INTERNATIONAL 420 CLASS RULES

201~~43~~-v3

Diagram 2

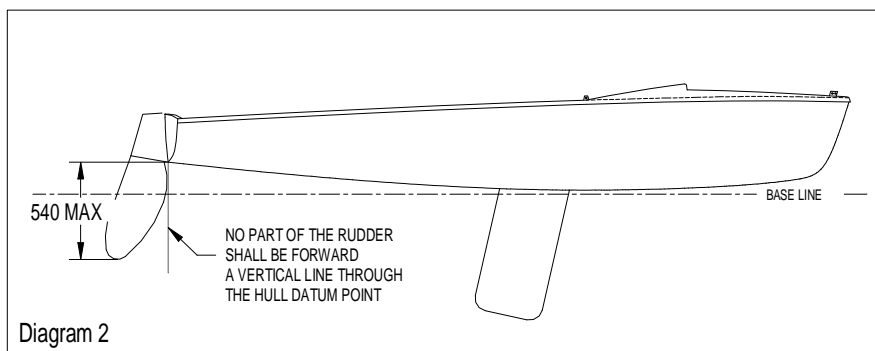
No part of the **rudder** blade, when fully lowered, shall extend more than 540 mm below the HDP. The leading edge of the **rudder** blade shall not be forward of a vertical line through the HDP (see measurement diagram 2).

Comment [DD10]: New rule

DIAGRAM 3

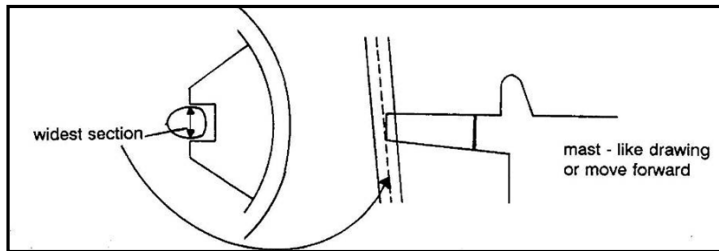
1) ~~Chocks may be used to control the~~ The fore and aft bend of the **mast spar** at the mast partner level may be limited either by chocks or by an optional system of single piece of rope, one attachment, one grip and one cleat without moving parts, on top of the mast partner. ~~Chocks or an additional system of single piece of rope, one attachment, one grip and one cleat without moving parts on top of the mast partner may be used to induce bend to the mast or to keep it from inverting.~~

Comment [DD11]: This is a major change in the way the boat is sailed, making it easier to adjust the bend but only locally. In addition, provision is made for a safety arrangement to prevent mast inversion when the mast partner is not closed

With the mast spar in its most forward position, the grip or end of rope of the aft bend control shall not be more than 150mm from the mast partner. With the mast in its aft most position the grip of the forward bend control shall not be more than 150mm from the mast partner.

Diagram 12

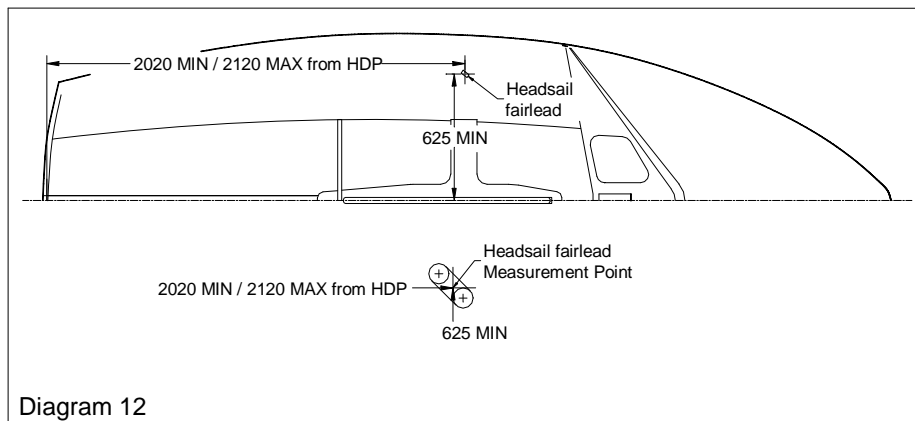
- (e) Two headsail fairleads, the measurement point of which shall be at 2020 mm minimum and 2120 mm maximum from the HDP and **625** mm minimum from the **centreline**. The fairleads shall be fixed directly to the buoyancy tanks (see diagram 12).

Comment [DD15]: 1250mm minimum distance from one port side fairlead to the starboard side fairlead.

Easier to check at events.

The distance may be reduced to 1150mm or less, so that windward sheeting is not needed as it is today.

Exact value to be confirmed following tests.

Diagram 17

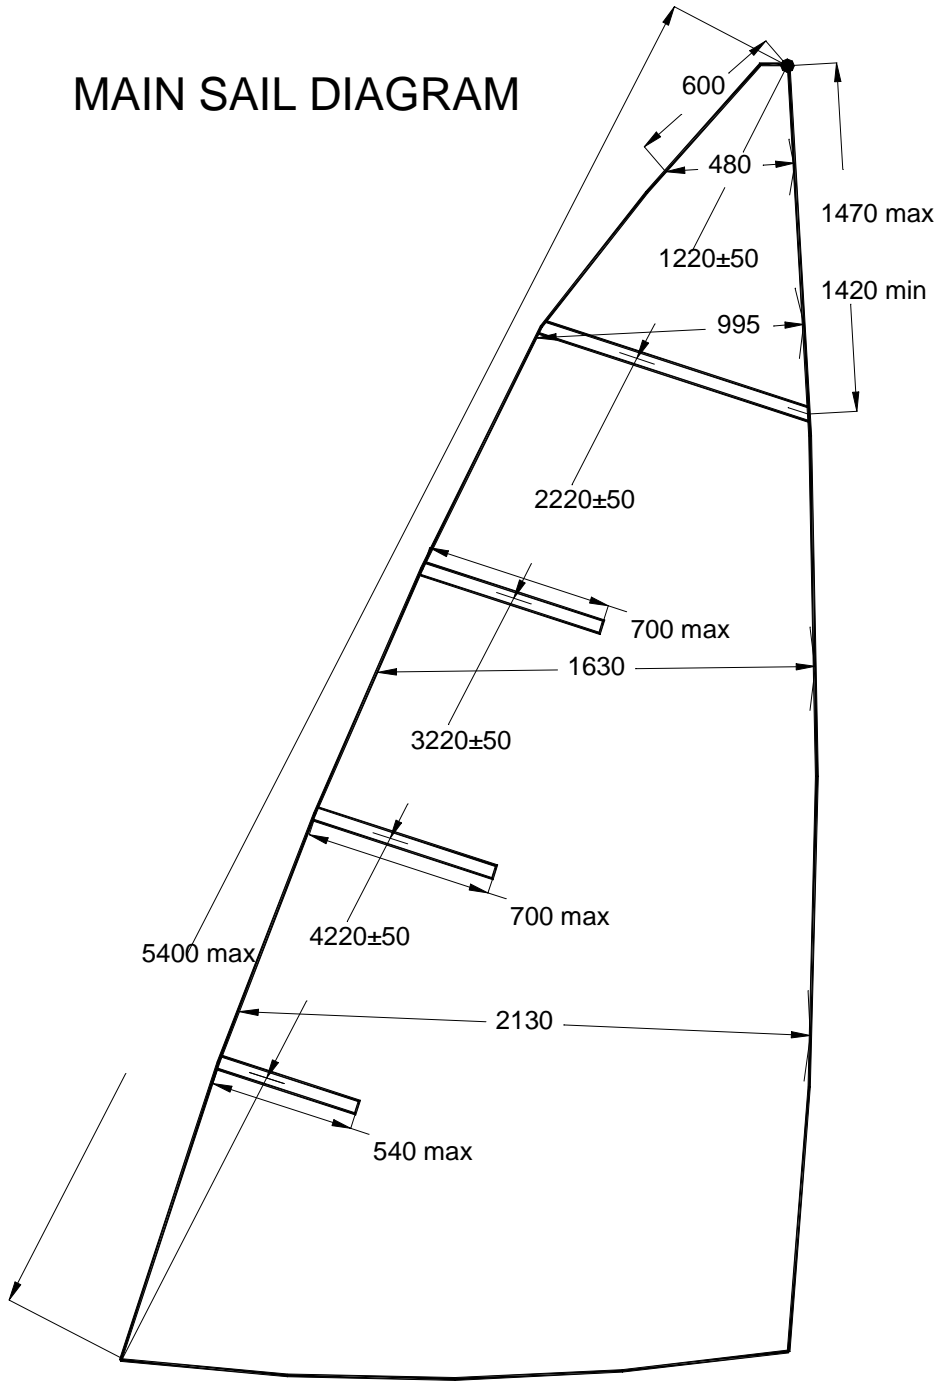
The batten pocket position as shown in diagram 17 shall be measured with the leech flattened by folding/flaking.
